**5.0 Design Development**

### 5.1 - Discussion with Camden Council Design Officer 22.09 2010

Fig - 5.1.4 - Sketch views from critical points

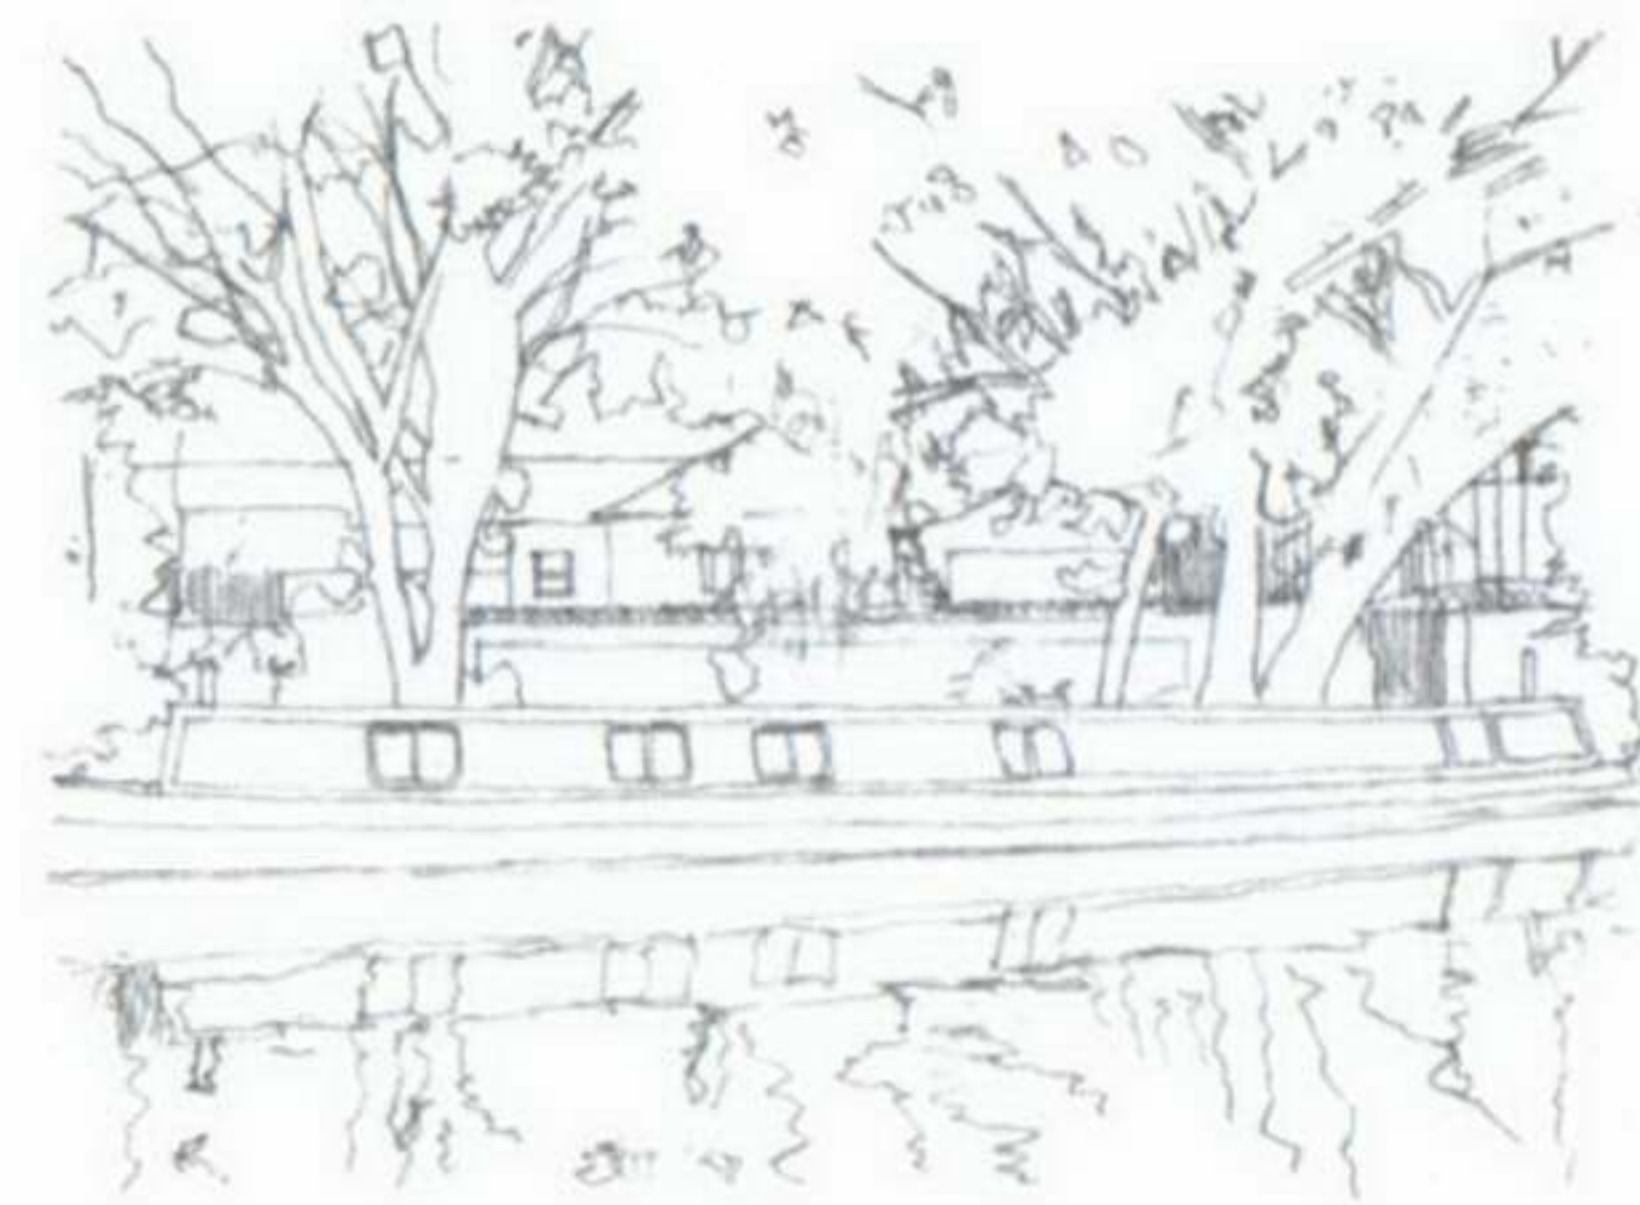
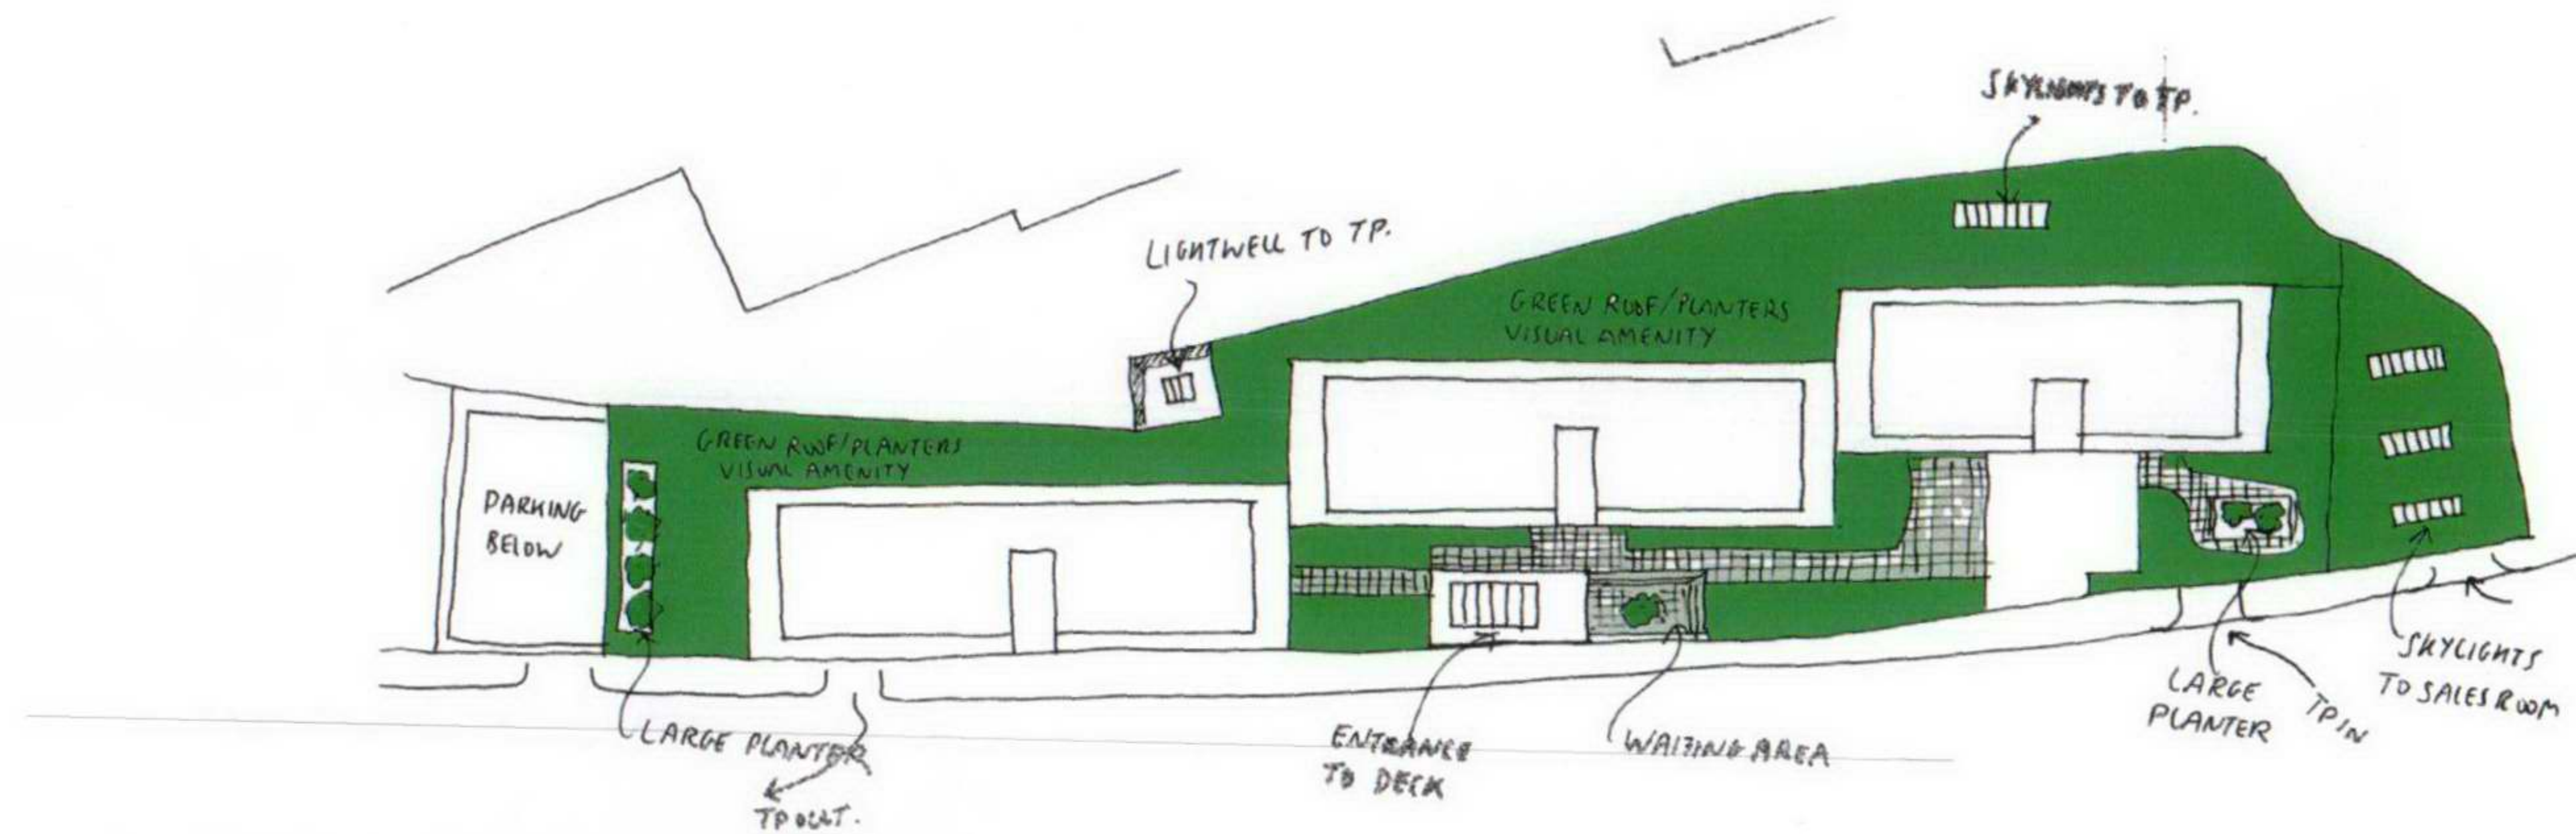
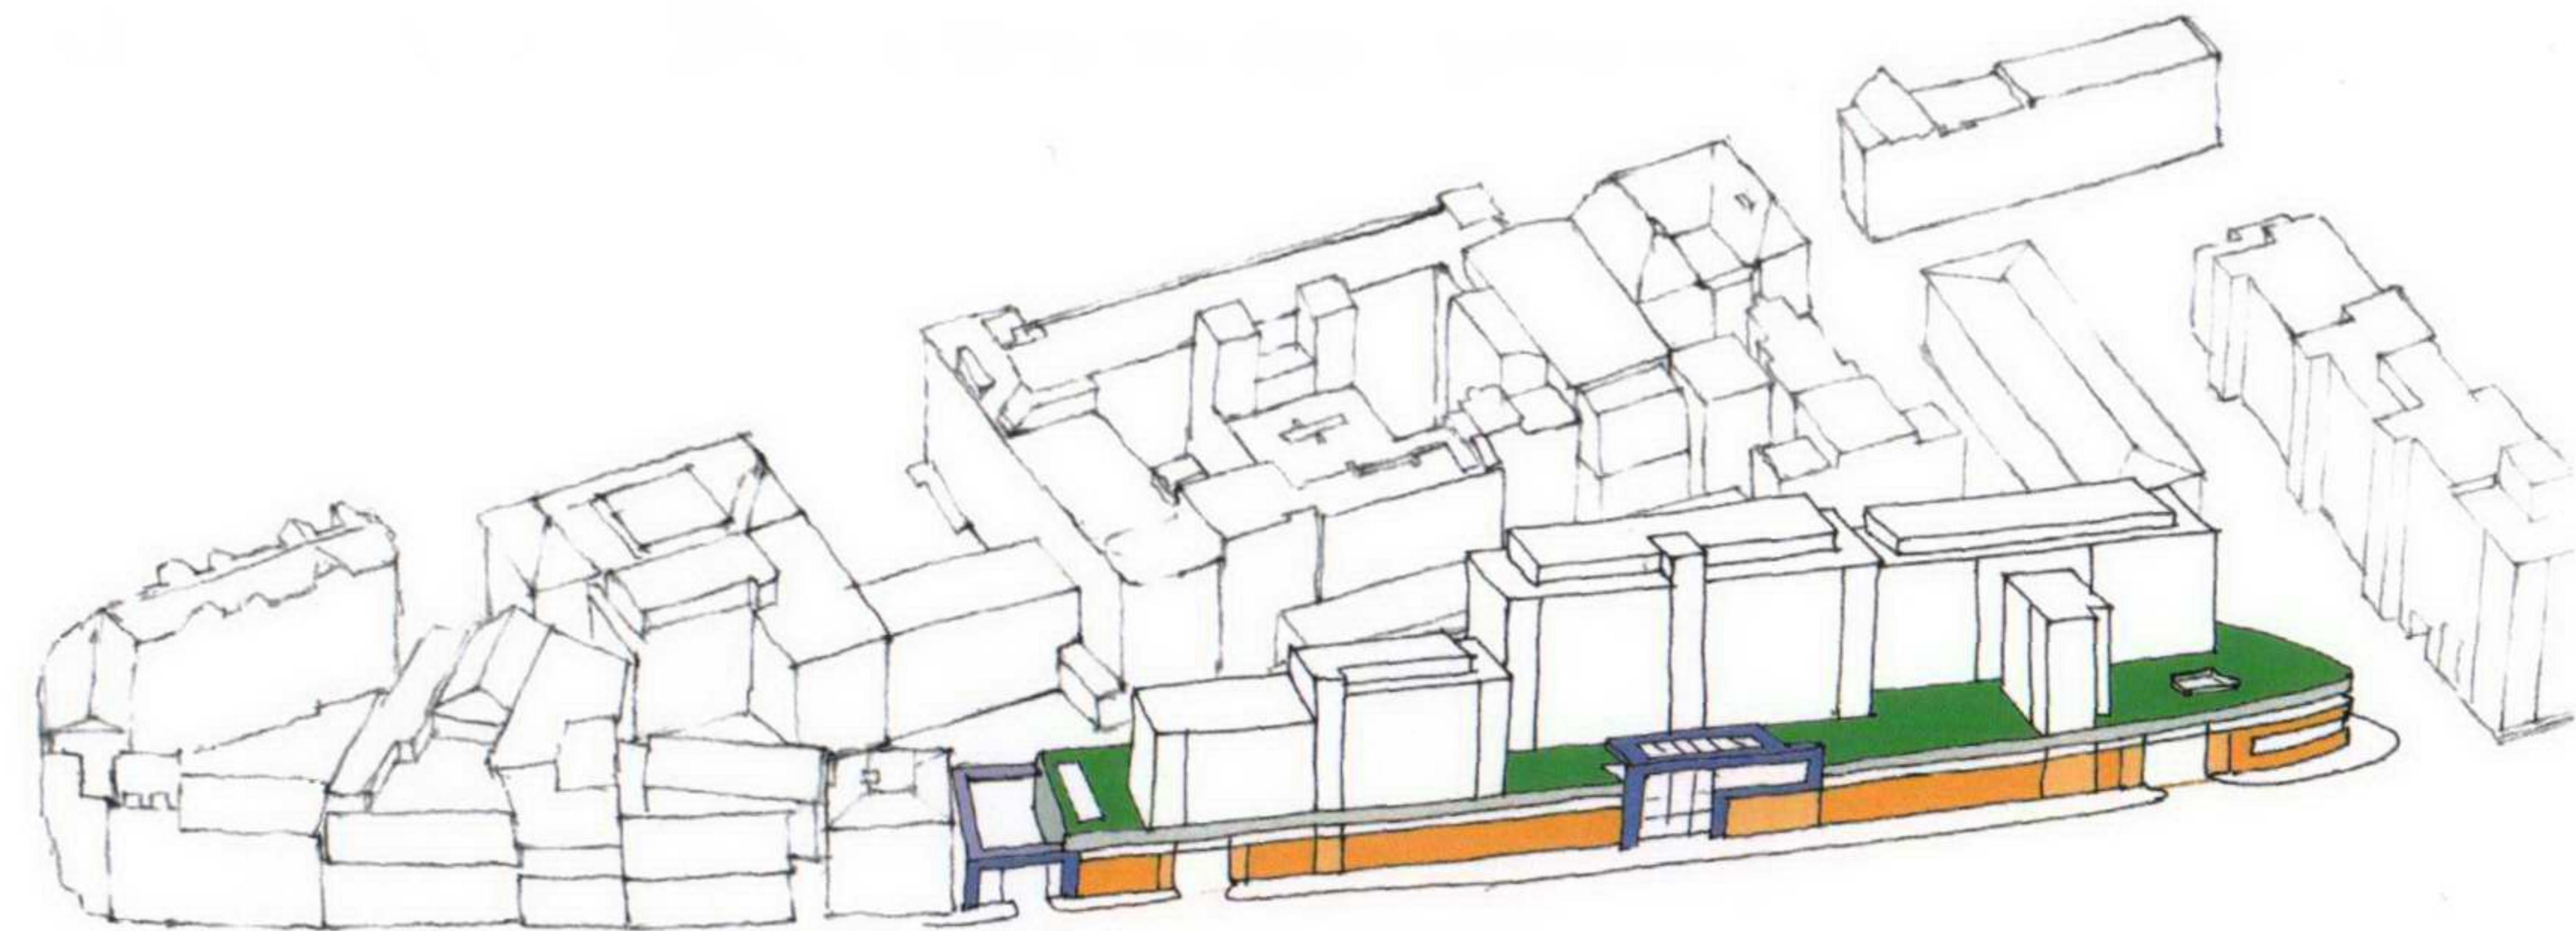
- The conceptual development and principles were discussed.
- The general revised layout of the site was considered to be successful in breaking up the mass of the building and in making a strong composition.

- The wall between the road and St Pancras Way was discussed in some detail. It was preferred that there should be more transparency in the wall. The builders merchants' activities bring a lot of life to the street and to hide it all behind a solid wall could detract from that. The Travis Perkins shop position should be more prominent.

- Whilst it was accepted that signage is necessary, it was preferred that it be well designed and not overbearing.
- The wall needs more detailed input.

- The elevations themselves need designing in a way that is in keeping with the building's concept. Further work is required on this point.
- It was suggested that in our approach to the podium level design we should promote as open a space as possible with a collegiate feel.

- We were encouraged to investigate how to express the modular nature of the design.
